Architect's Supplemental Instructions

Architect's ASI No: 044

Project:
Webster University
Interdisciplinary Science
Building

Discipline Code: 03 Electrical

SHEET E0101.A LEVEL 01 AREA A FLOOR PLAN – ELECTRICAL & AUXILIARY

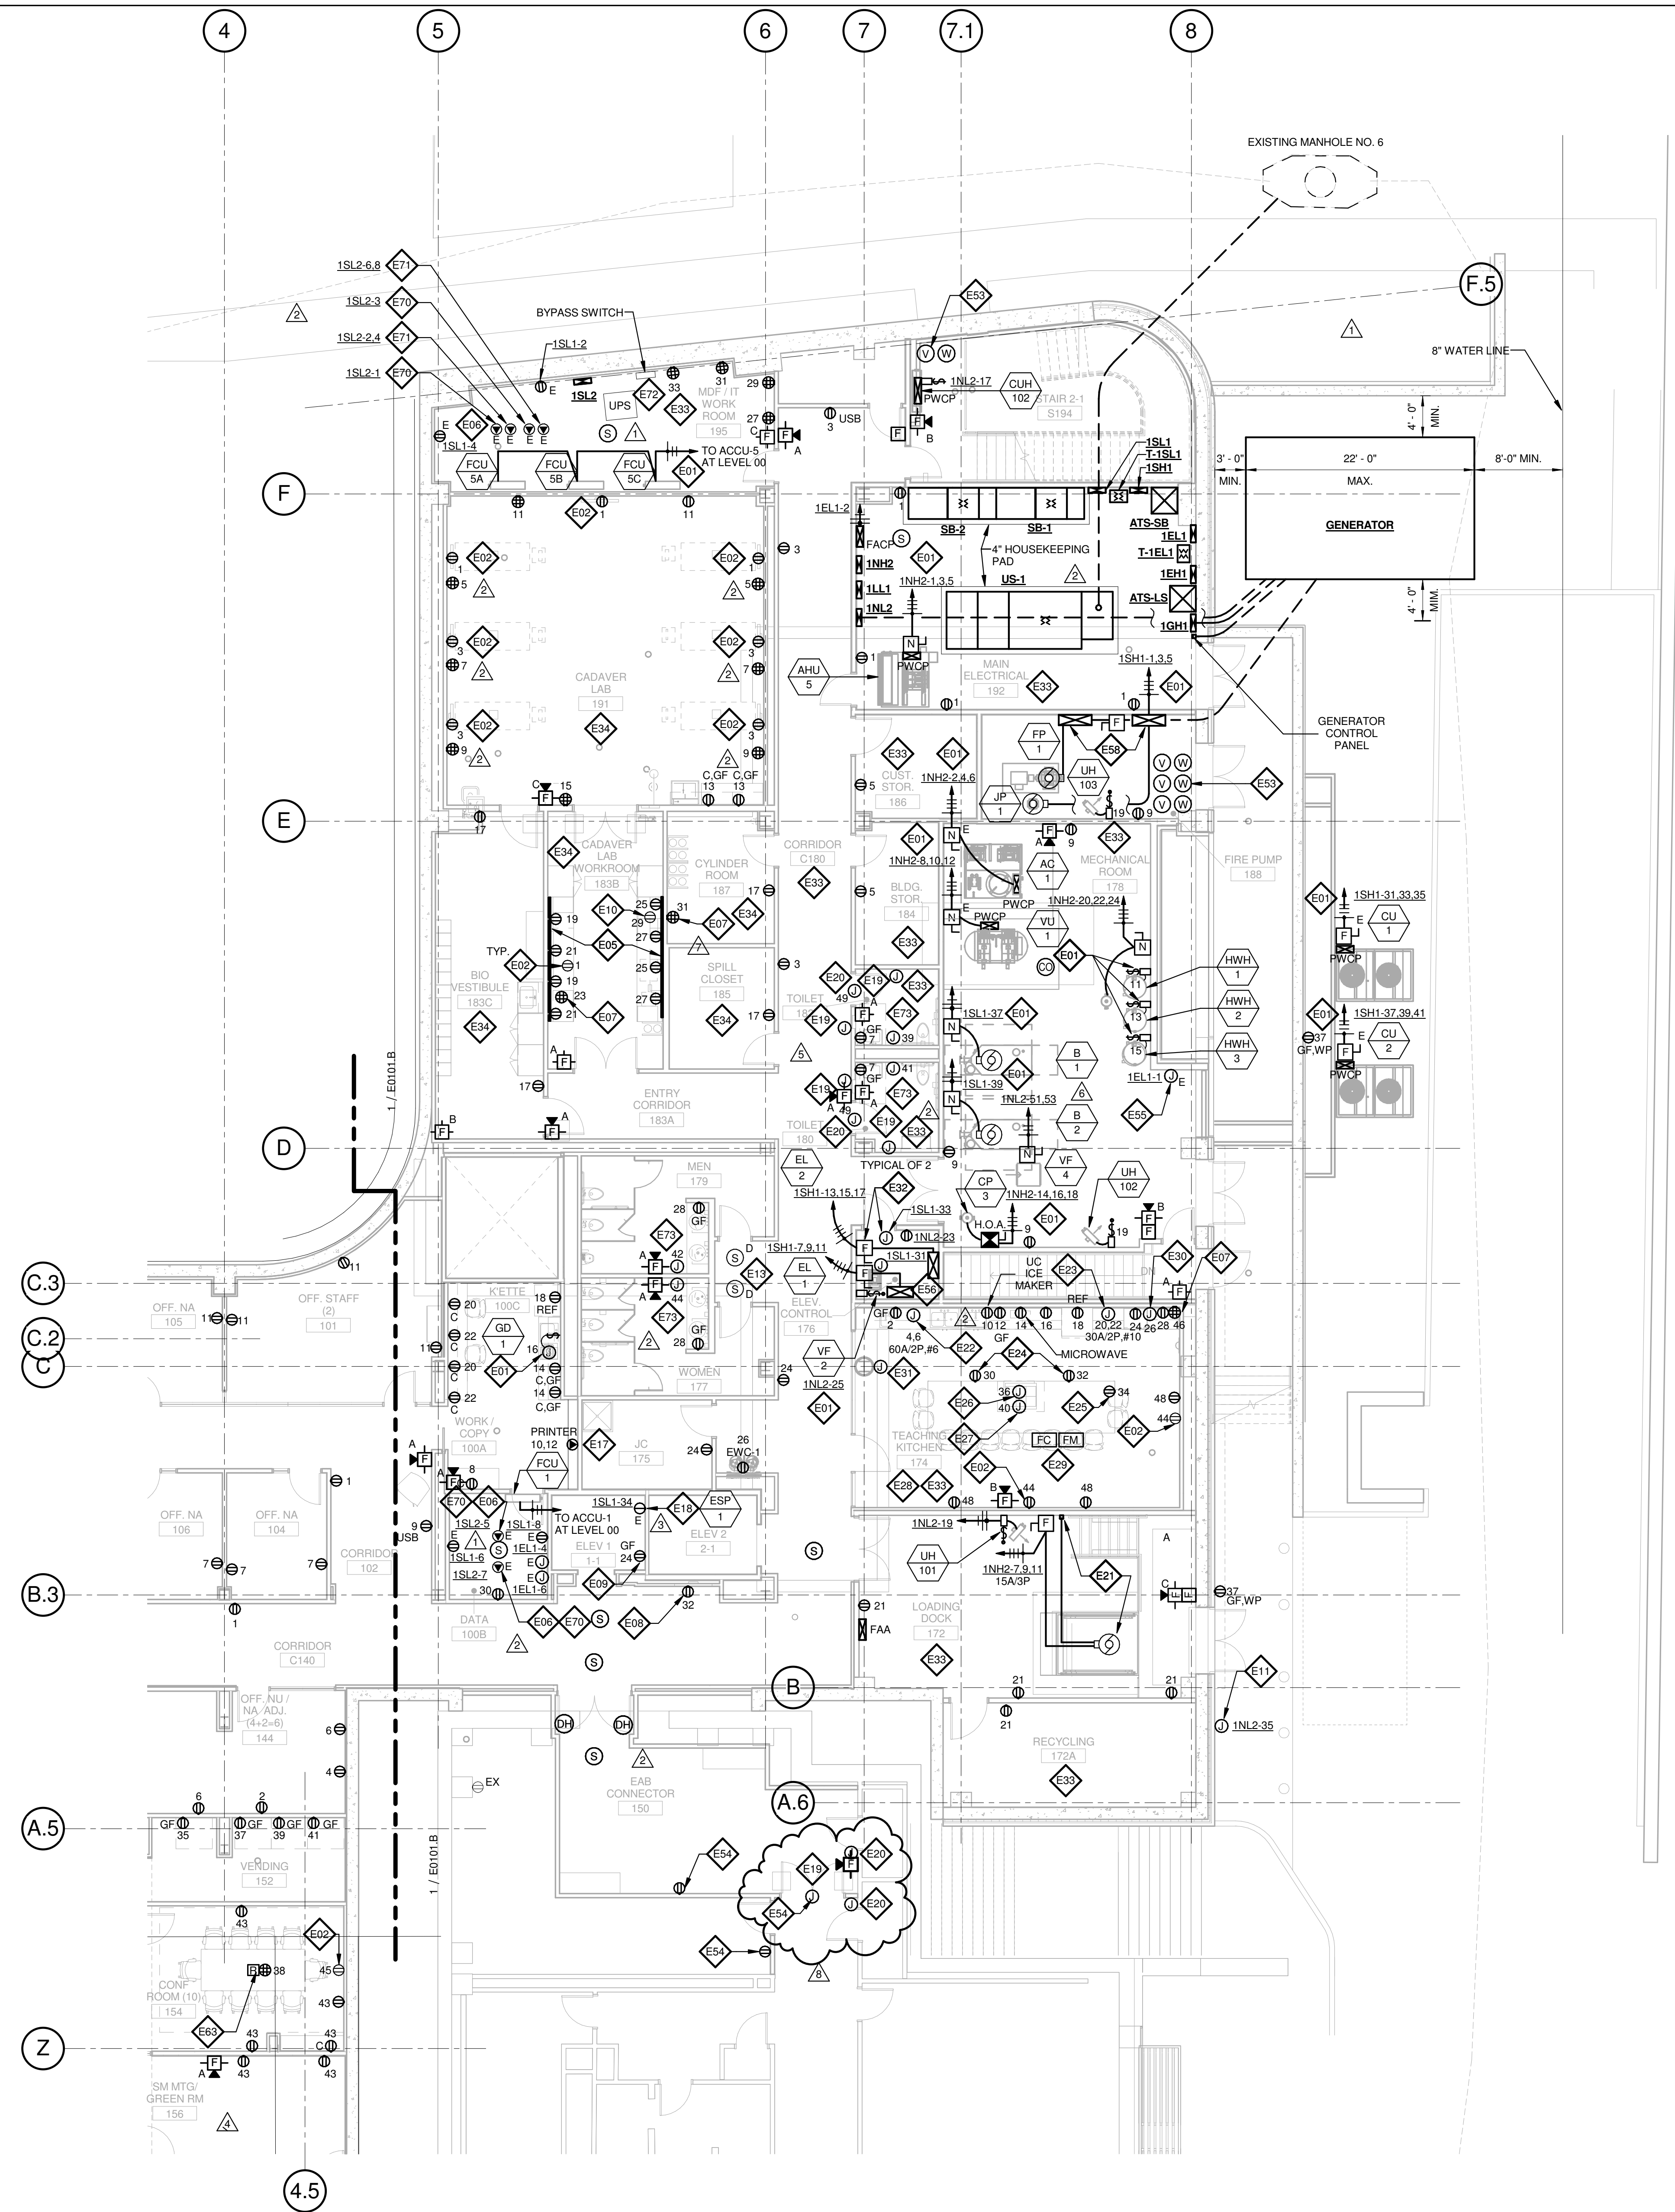
- In EAB Connector 150, provide motorized door opener to serve door 150 and connect to existing circuit serving area.

SHEET E0102.A LEVEL 02 AREA A FLOOR PLAN – ELECTRICAL & AUXILIARY

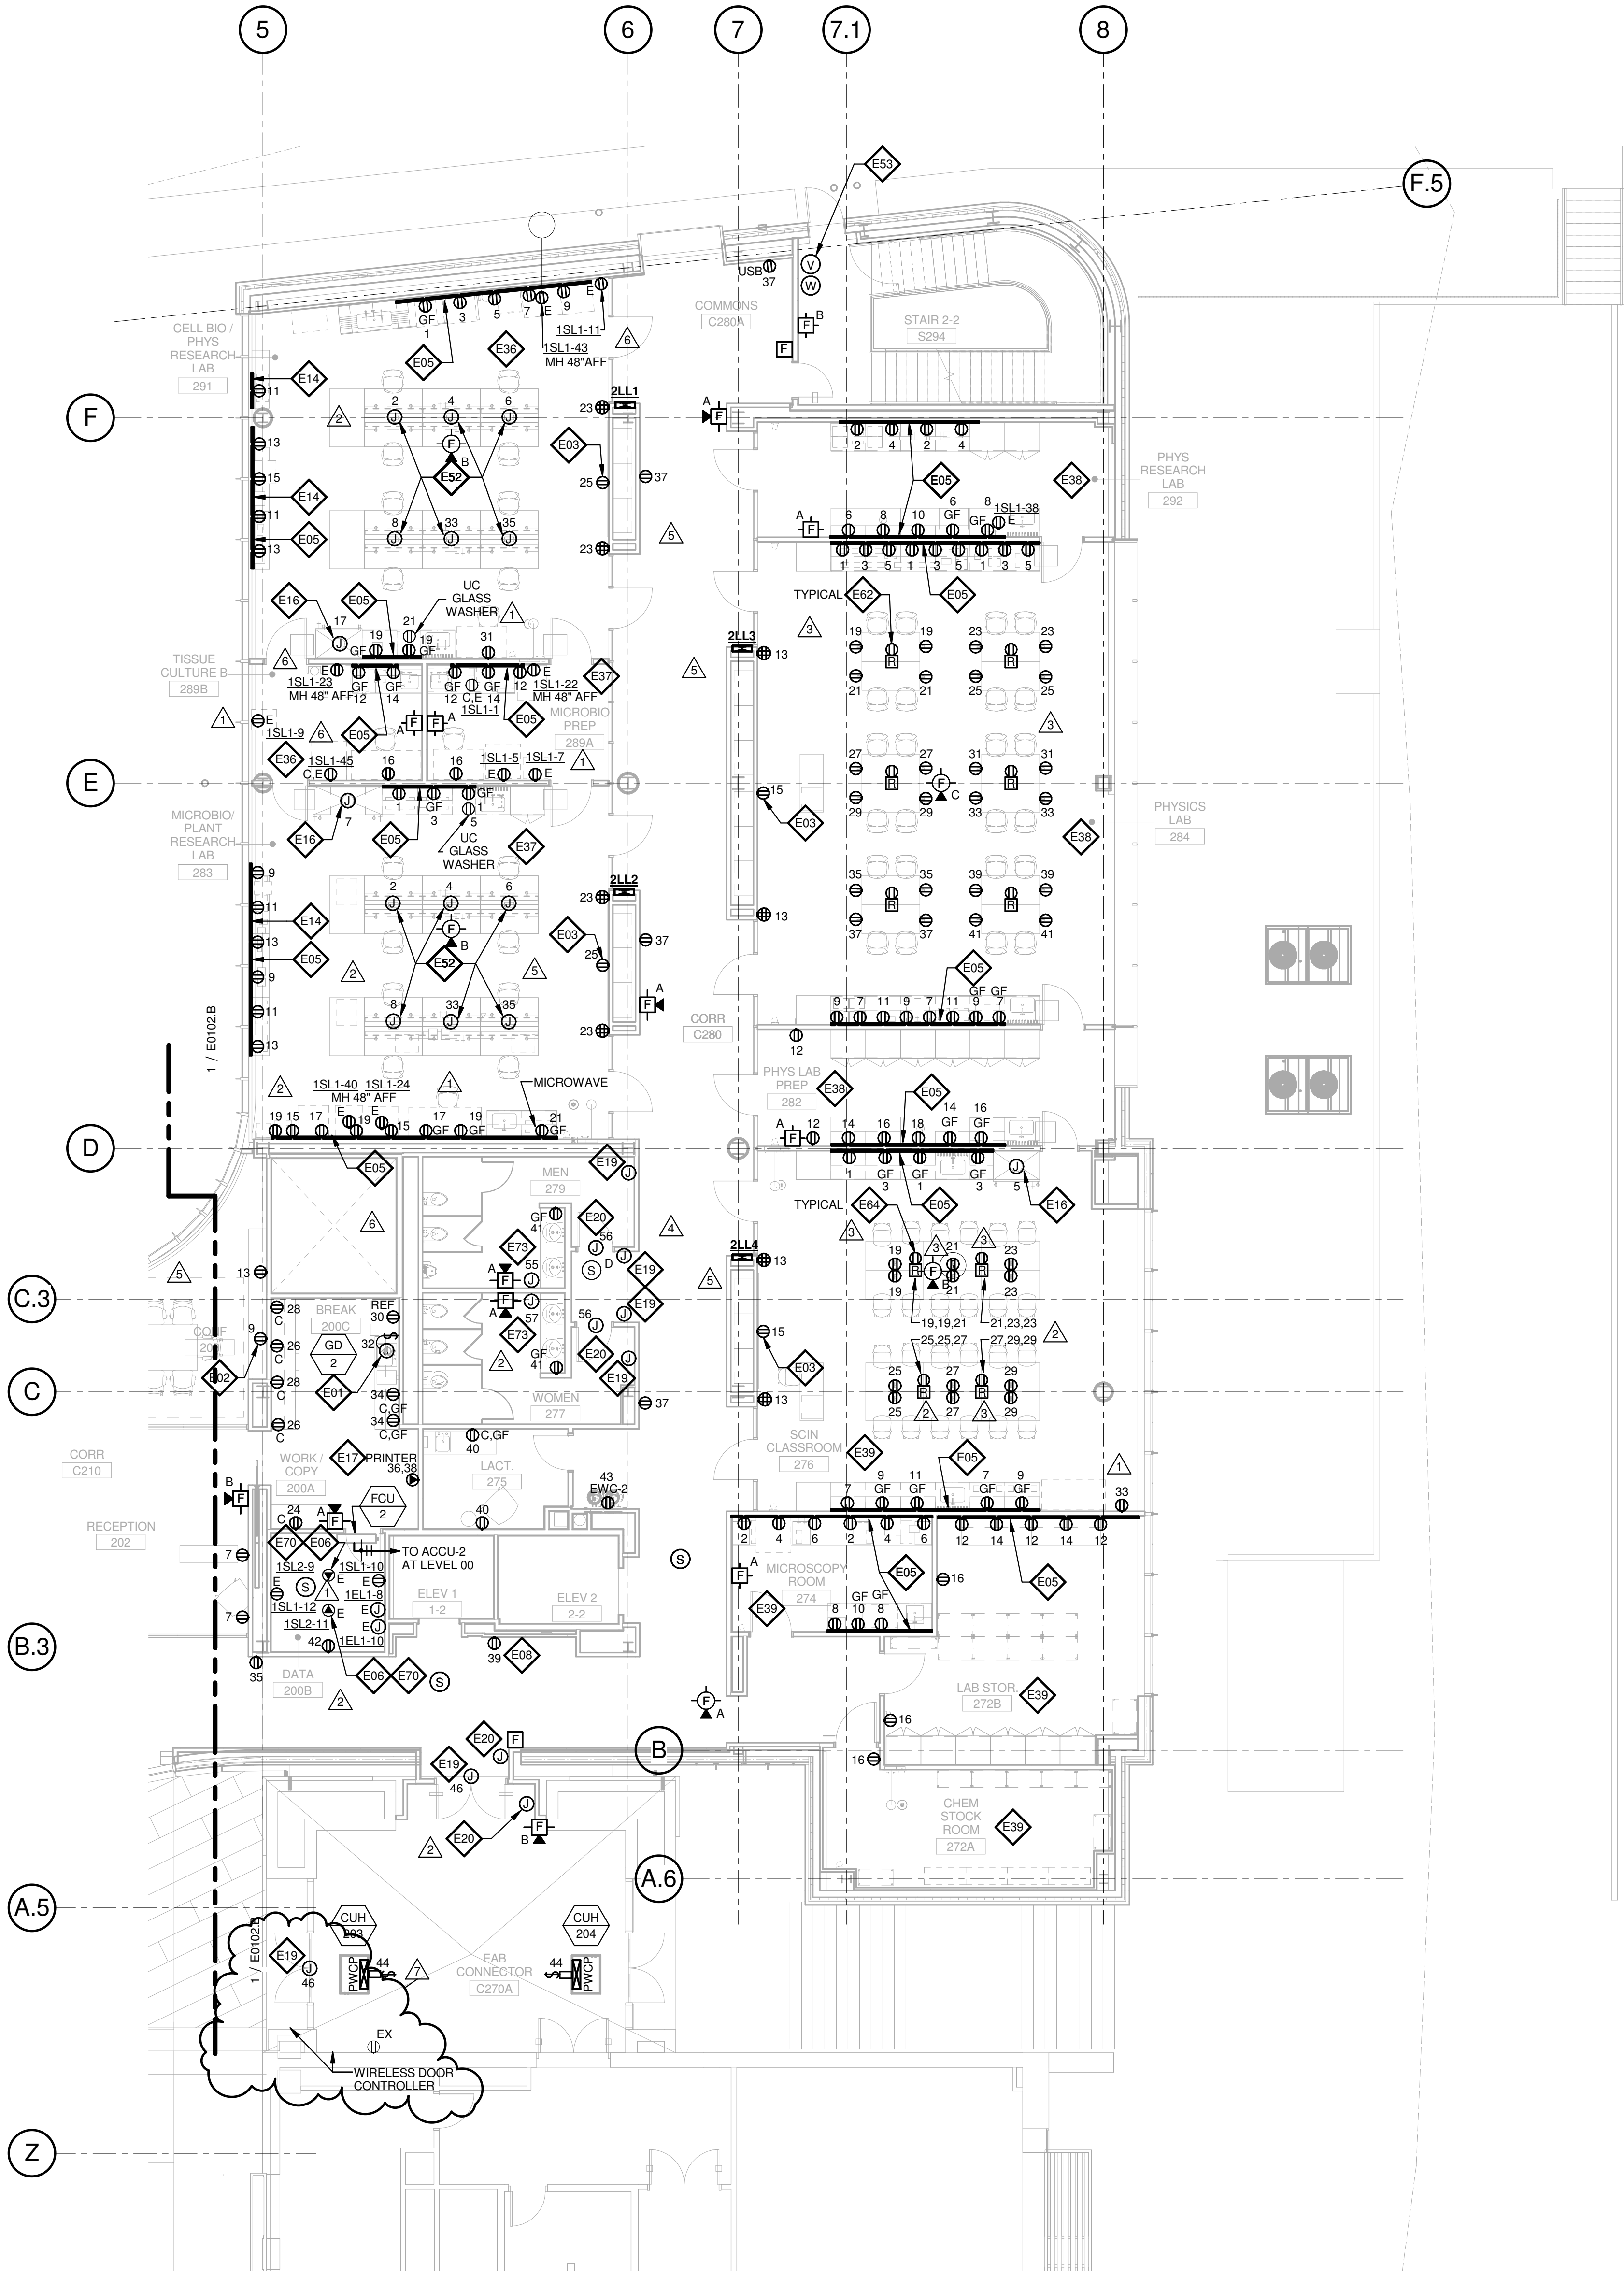
- In EAB Connector C270A, provide motorized door opener to serve door XC270A.1 and connect to circuit 46 serving adjacent door.
